Dean Moor Solar Farm

Environmental Statement: Chapter 7 – Figure 7.6 1-5 Landscape Strategy Plan on behalf of FVS Dean Moor Limited

26 August 2025
Prepared by: Stantec UK Ltd
PINS Ref: EN010155
Document Ref: D2.28
Deadline: 2
Revision: 2

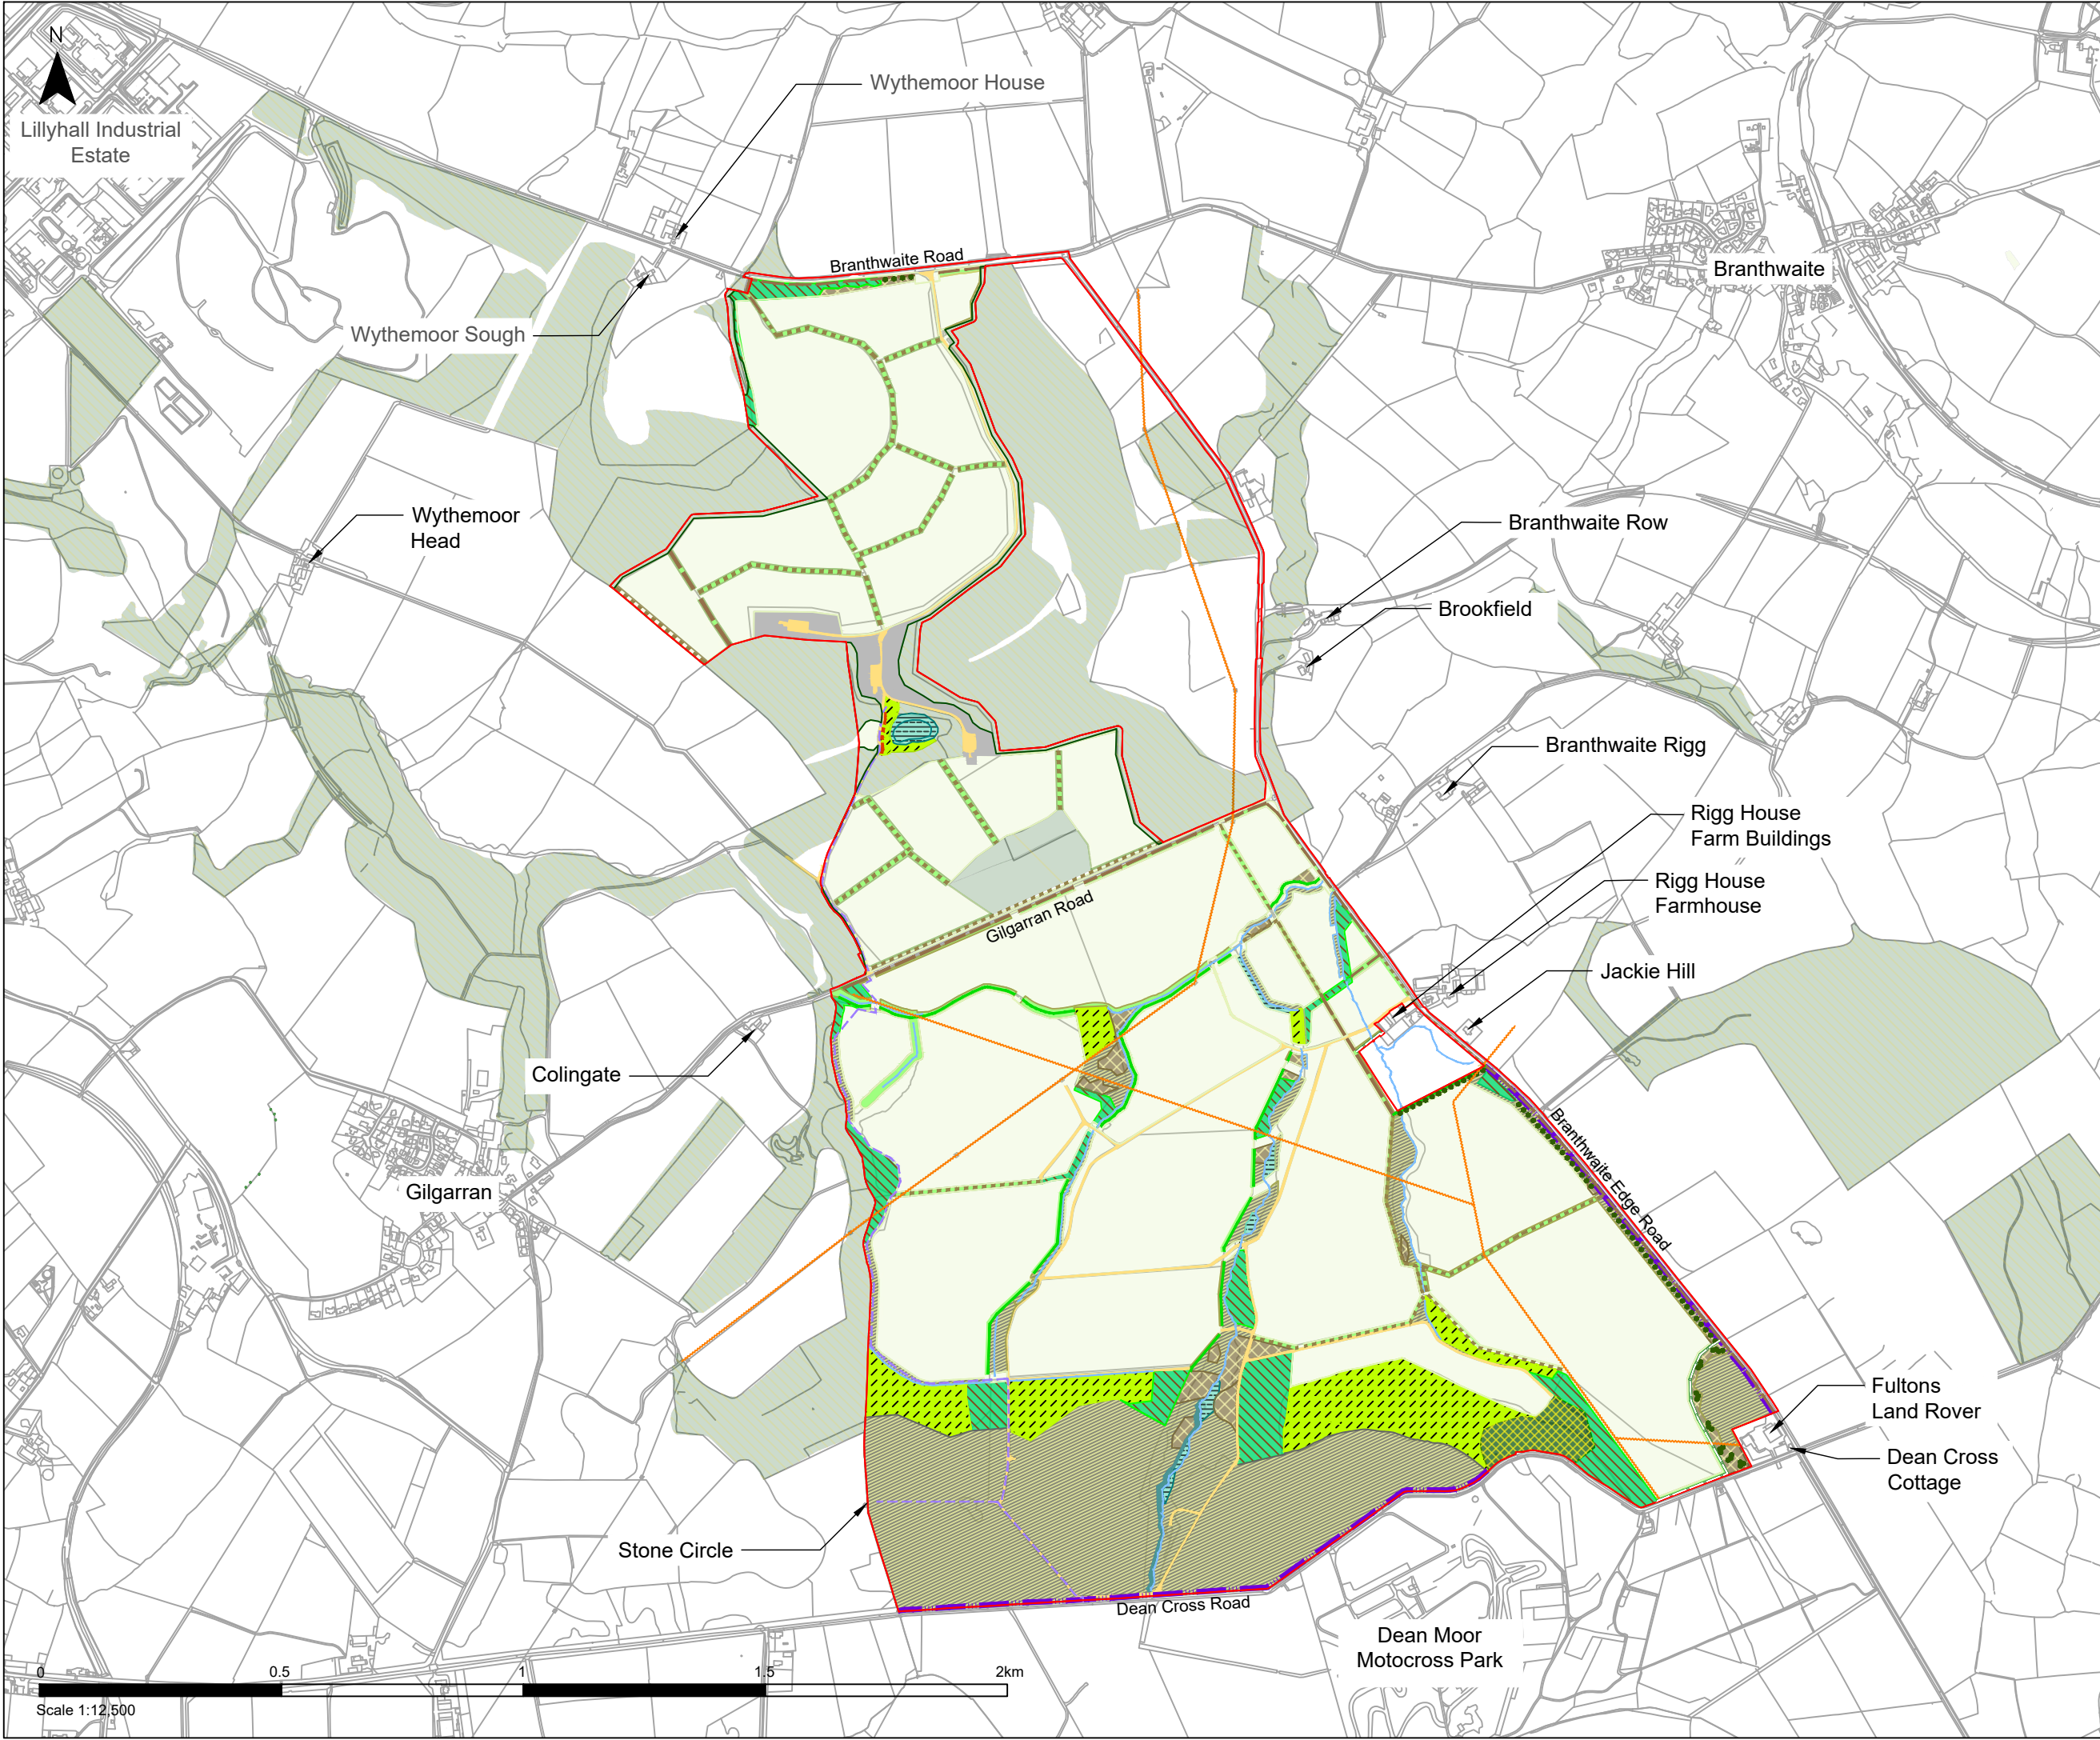
Revision	Reason
Dry stone wall line-style updated to darker purple and dashed	<p>Q6.0.2 of the Examining Authority's (ExA) first written questions stated:</p> <p><i>"The Landscape Strategy plan [APP-088] includes a number of colour coded features which are similar and difficult to discern (for example, existing and proposed hedgerows). Please amend."</i></p>
Willow screening hedge line-style changed to smaller dash and changed from green to reddish/brown	
Existing woodland (Coniferous) updated to crosshatch (easier to distinguish between coniferous/broadleaved)	
Acid grassland hatch changed to differentiate better between this and existing woodland	
Native planting to protect watercourse changed colour to darker blue	
Marginal planting hatch colour made slightly lighter blue to distinguish between this and native planting to protect watercourse	
All hedge line-styles/colours changed to make it easier to distinguish between them

Other grassland colour made lighter	
Broadleaf woodland hatch changed to distinguish better between grassland and woodland colours

<table><tr><td>B</td><td>GRAPHIC AMENDMENTS TO LINETYPES/HATCHES</td><td>IM</td><td>AC</td><td>2025.08.12</td></tr></table>

Figure: 7.6.2

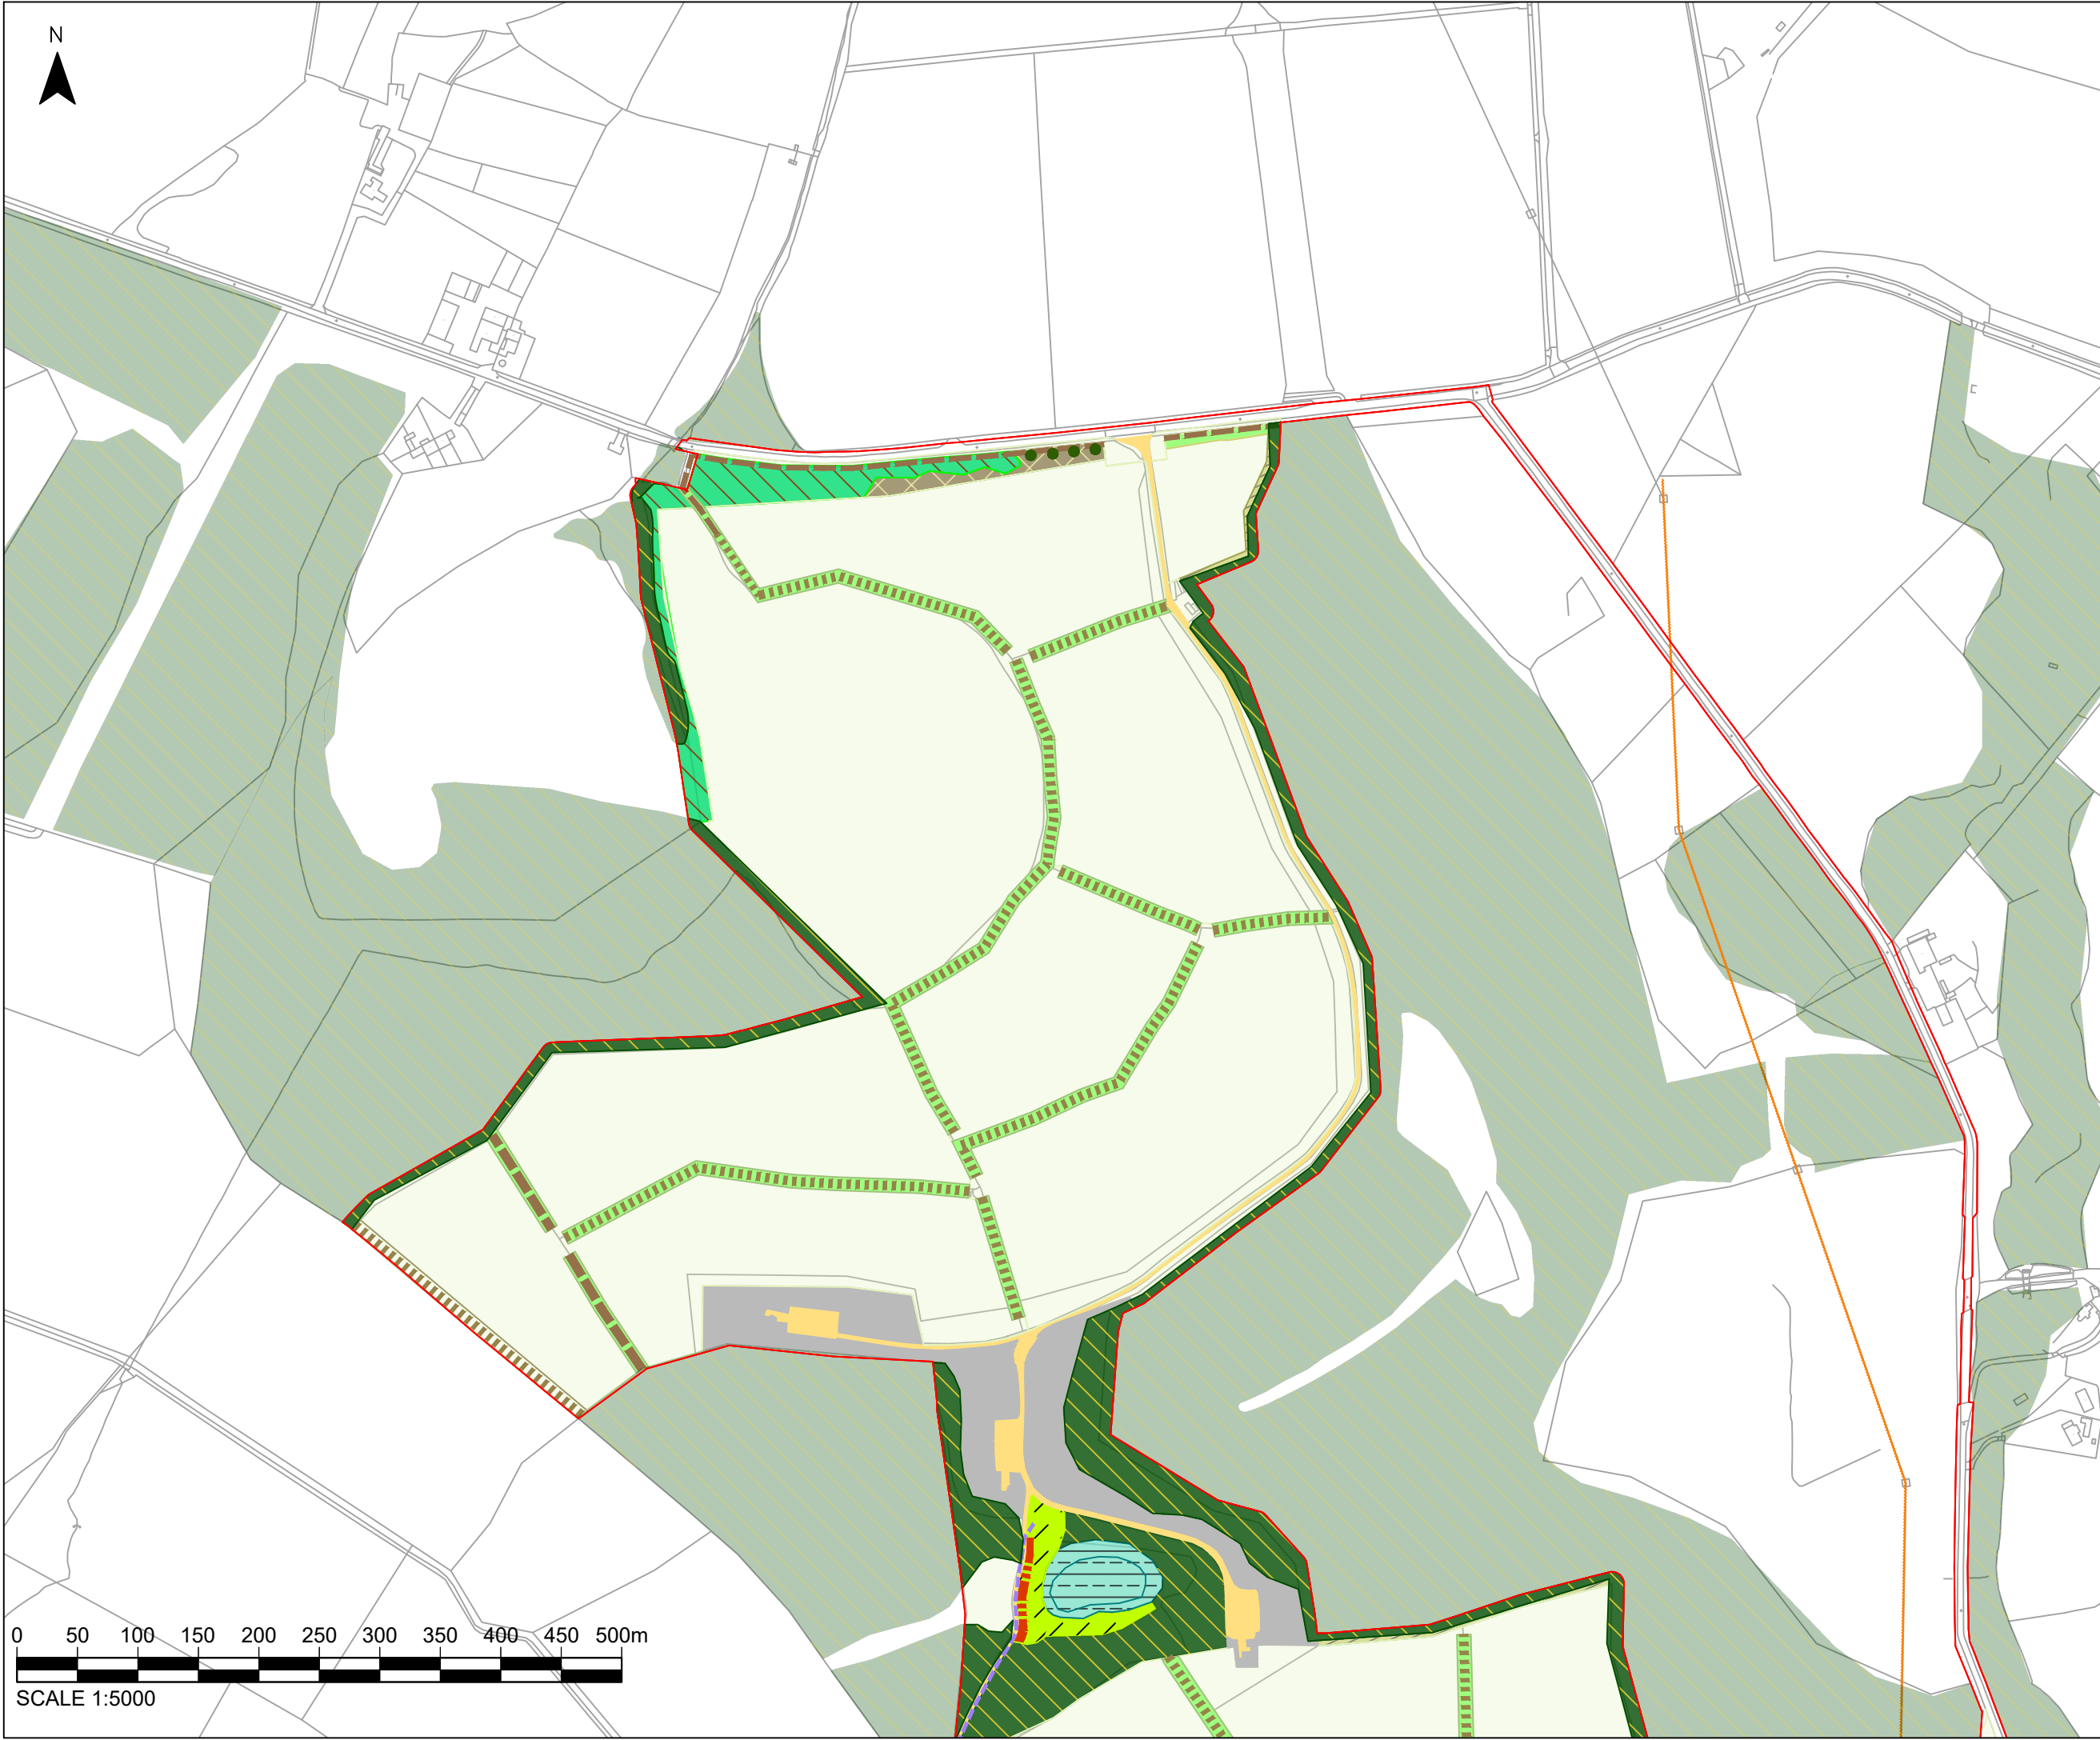
B	GRAPHIC AMENDMENTS TO LINETYPES/HATCHES	IM	AC	2025.08.12
A	FIRST ISSUE	MB	AC	2025.01.16
Issued/Revision		By	Appd	YYYY.MM.DD
